Hon Dr Steven Miles  
 Deputy Premier  
 Minister for State Development, Infrastructure, Local Government and Planning  
 Minister Assisting the Premier on Olympics Infrastructure  
 c/- Director, Development Assessment Division - Planning Group  
 Department of State Development, Infrastructure, Local Government and Planning  
 PO Box 15009  
 CITY EAST QLD 4002  
[deputy.premier@ministerial.qld.gov.au](mailto:deputy.premier@ministerial.qld.gov.au) | [ministerial.callin@dSDLGP.qld.gov.au](mailto:ministerial.callin@dSDLGP.qld.gov.au)

**Re: Wanless Recycling Park (Ministerial Call-in Ref: MBN2272) Submission (Objection) Application for Development Permit for a Material Change of Use & Development Permit for an Environmentally Relevant Activity & Development Permit for a Reconfiguration of a Lot – Located at: 82A, 82B, 82C, 82D, 82E, 82F & 82H Lanes Road, Ebenezer QLD 4340; Lot 312 & Lot 1 (under road licence) Coopers Road, Ebenezer QLD 4340; 266-304 & 350 Coopers Road, Willowbank QLD 4306; 166-198 & 202-282 Bergmans Road, Ebenezer QLD 4340; Lot 257 Unnamed Road, Ebenezer QLD 4340**

## **Re: PEER REVIEW - AIR QUALITY ASSESSMENT, PROPOSED WANLESS RECYCLING PARK, WILLOWBANK**

## **R

Figure 1: Wanless and [REDACTED] sites in relation to the Amberley RAAF Base.

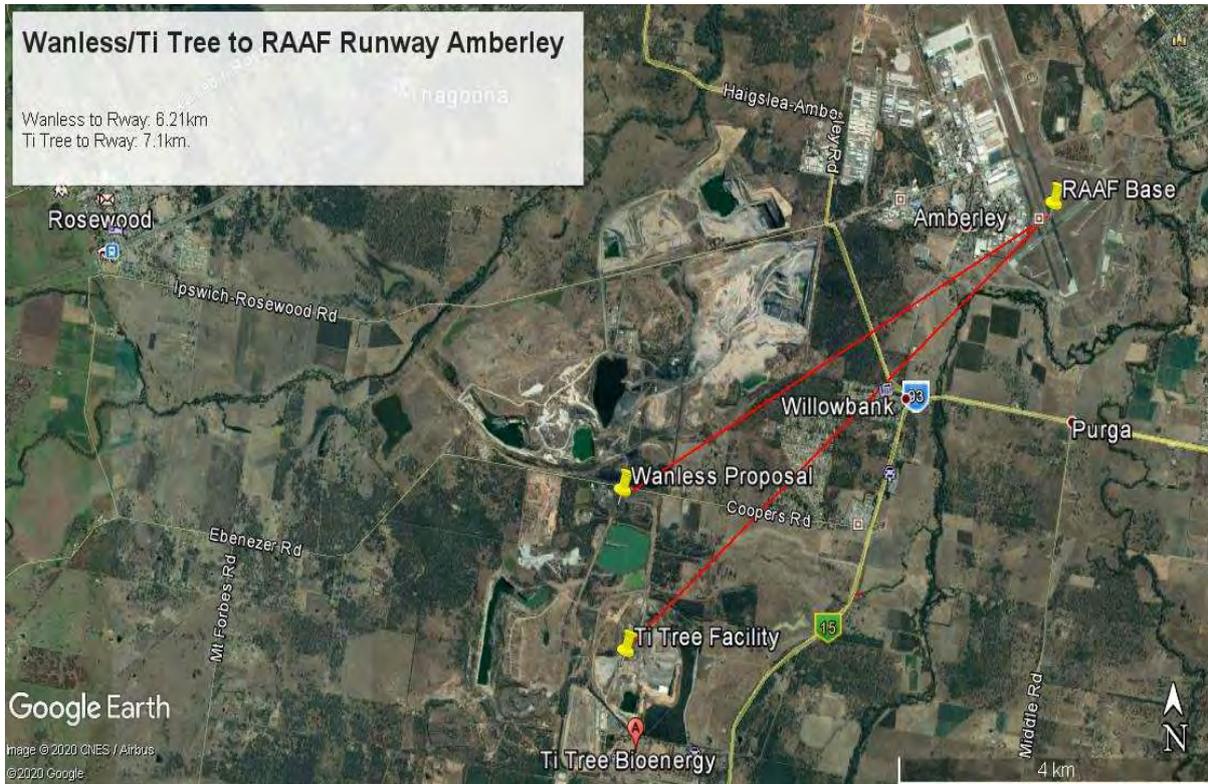
- The proposed Wanless Facility will be approximately 6.2 kms from the Base runway while [REDACTED] Waste Facility is located approximately 7.1 km from the runway (see figure 1).

- A Site Operating Procedure (SOP-13) for bird management is mentioned in sections 4.2 and 6.7.6 of the Plan. The SOP has not been provided to the client

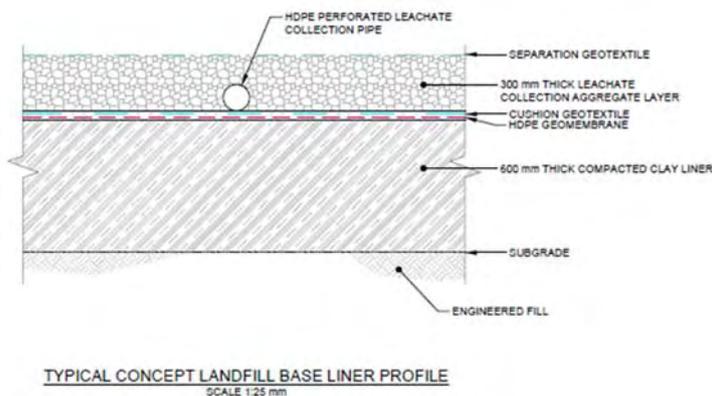
29. *(p8, Section 3.3) This report states: As part of the development (LIP) reprofiling void batters will be undertaken, dewatering and subgrade improvement works to support the containment system.*

There are no details on the dewatering of the LIP. There is a considerable volume of water retained within the pit, that will need to be removed prior to any earthworks or landfill development being possible (controlled by the need to access the base of the void for reprofiling purposes). It cannot be considered to be safe to undertake works in one portion of a pit while another portion holds a depth of water, regardless of the extent of containment or separation. Therefore, it will be necessary to dewater the void to the fullest extent practical from the outset, then maintain ongoing inflows (surface water and groundwater) as the development progresses to ensure that the landfill is not inundated. The quality of water contained within the void is critical to pit dewatering. No baseline water quality data has been provided, although it can be expected that the upper water column would be relatively fresh, however due to the anticipated depth of water in the void, a temperature or salinity controlled interface would likely exist at some depth (possibly as shallow as 1.5m from the surface). It can be expected, particularly due to the period since mine closure and the enclosed nature of the pit, that water quality conditions below this interface would be very poor, likely being saline, anoxic, and with a high organic content. Typically, such water is very difficult and costly to treat to a standard required for discharge to the receiving environment. The required process may require aeration, biological (bacterial) treatment in addition nitrification/ denitrification and possibly reverse osmosis. Such a process would be very costly to establish and operate, with the treatment period likely to extend over a lengthy period, therefore compromising the overall development program. Groundwater is addressed in Section 3.4, however in the absence of a hydrogeological assessment, there is no understanding of the potential groundwater inflows to the dewatered pit, and the effort and cost required to keep the pit dry for landfill development purposes. This will be a long-term issue, until the landfill base rises above any potential groundwater level. In support of this concern, the drawings indicate a groundwater level around the LIP of around RL25m, which is some 35m above the proposed base.

**Figure 2.2: Existing Access on Champions Way**

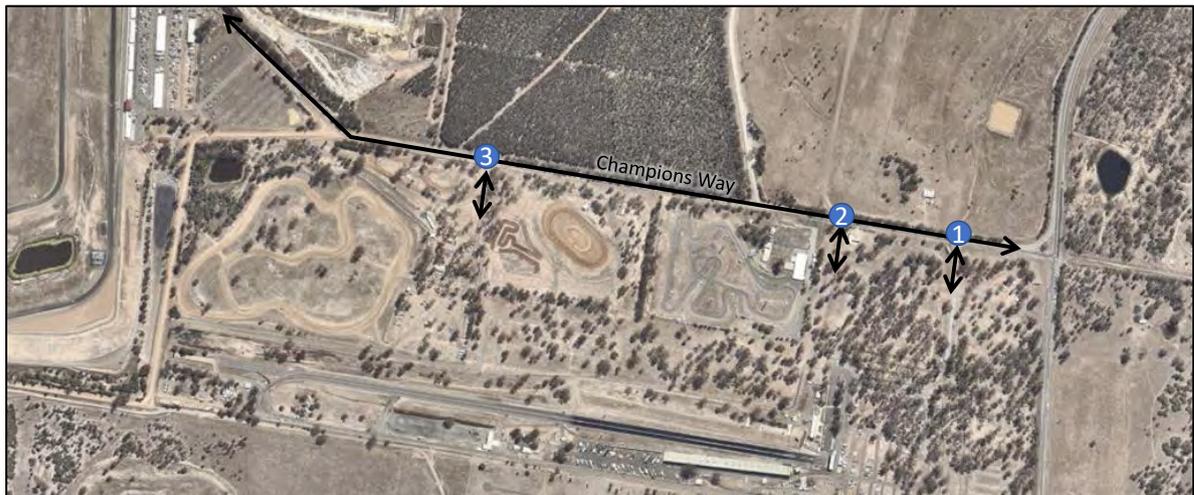
Figure 2.2 shows access to the Ipswich Motorsport Precinct along Champions Way.

- Site access proposed via Champions Way would appear contrary to the intent of maintaining an appropriate, safe and amenable traffic environment for the future planning intent of the Ipswich Motorsport Precinct. Furthermore, it is inconsistent with Council's Implementation Guideline No. 32 and Figure 5a (ERIA Transport and Access Network Plan) which includes access via Seppanaen Road as being within the preferred strategic road hierarchy and network within the ERIA.

TYPICAL CONCEPT LANDFILL BASE LINER PROFILE  
SCALE 1:25 mm

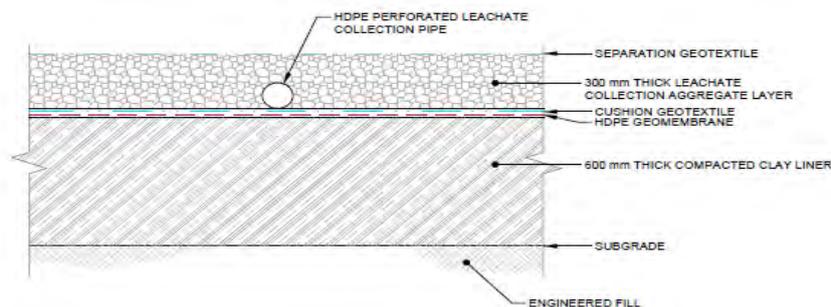
18. (p10, Section 3.4) *This revised report states: A groundwater drainage blanket comprising an aggregate layer spread across the whole of the base of the cell with a series of collection pipes within the aggregate.*

There are considerable irregularities and contradictions between the written description and associated drawings: This fact was pointed out in Attachment 2/Appendix E of [REDACTED] objection (3 June 2020). Refer below (Appendix I: Dwg F-050) As can be seen, this typical concept landfill base liner profile has no groundwater collection layer.

**Figure 2.2: Existing Access on Champions Way**

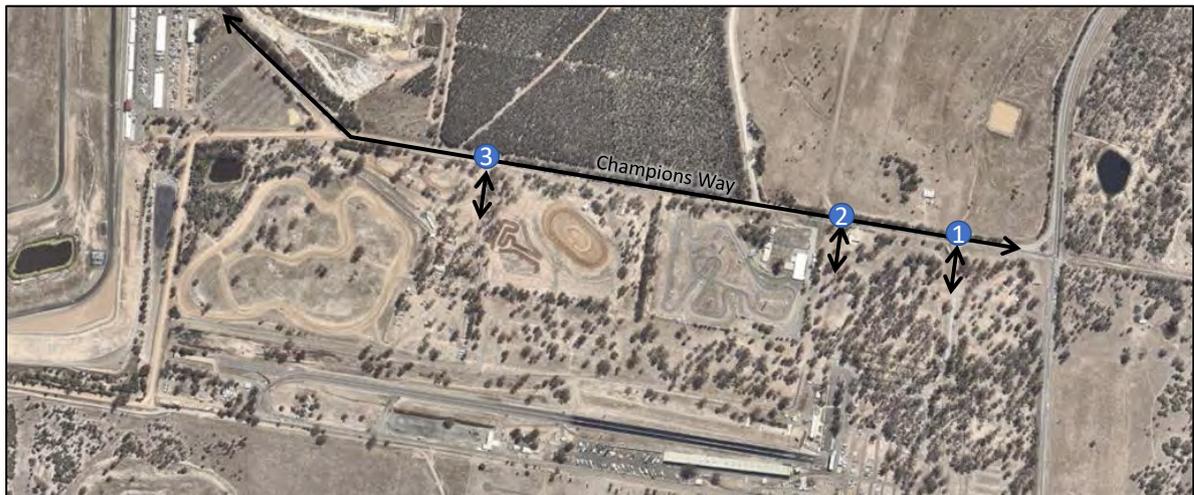
Figure 2.2 shows access to the Ipswich Motorsport Precinct along Champions Way.

- Site access proposed via Champions Way would appear contrary to the intent of maintaining an appropriate, safe and amenable traffic environment for the future planning intent of the Ipswich Motorsport Precinct. Furthermore, it is inconsistent with Council's Implementation Guideline No. 32 and Figure 5a (ERIA Transport and Access Network Plan) which includes access via Seppanaen Road as being within the preferred strategic road hierarchy and network within the ERIA.

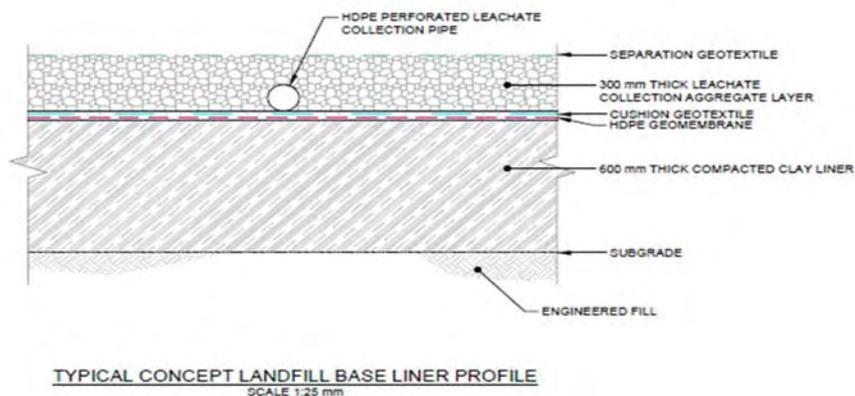
23. **(p9, Section 3.3.1)** This revised report states: *As part of the development (LIP) reprofiling void batters will be undertaken, dewatering and subgrade improvement works to support the containment system.*

The report in **Appendix H** only refers to sediment testing of the **tailings dam** – i.e., there is **no mention of Lanes and Ironbark Pits (LIP)**.

There are no details/management protocols on the dewatering of LIP. As there is a considerable volume of water retained within the pit, that will need to be removed prior to any earthworks or landfill development being possible (controlled by the need to access the base of the void for reprofiling purposes). It cannot be considered to be safe to undertake works in one portion of a pit while another portion holds a depth of water, regardless of the extent of containment or separation. Therefore, it will be necessary to dewater the void to the fullest extent practical from the outset, then maintain ongoing inflows (surface water and groundwater) as the development progresses to ensure that the landfill is not inundated. The quality of water contained within the void is critical to pit dewatering. No baseline water quality data has been provided, although it can be expected that the upper water column would be relatively fresh, however due to the anticipated depth of water in the void, a temperature or salinity-controlled interface would likely exist at some depth (possibly as shallow as 1.5m from the surface). It can be expected, particularly due to the period since mine closure and the enclosed nature of the pit, that water quality conditions below this interface would be very poor, likely being saline, anoxic, and with a high organic content. Typically, such water is very difficult and costly to treat to a standard required for discharge to the receiving environment. The required process may
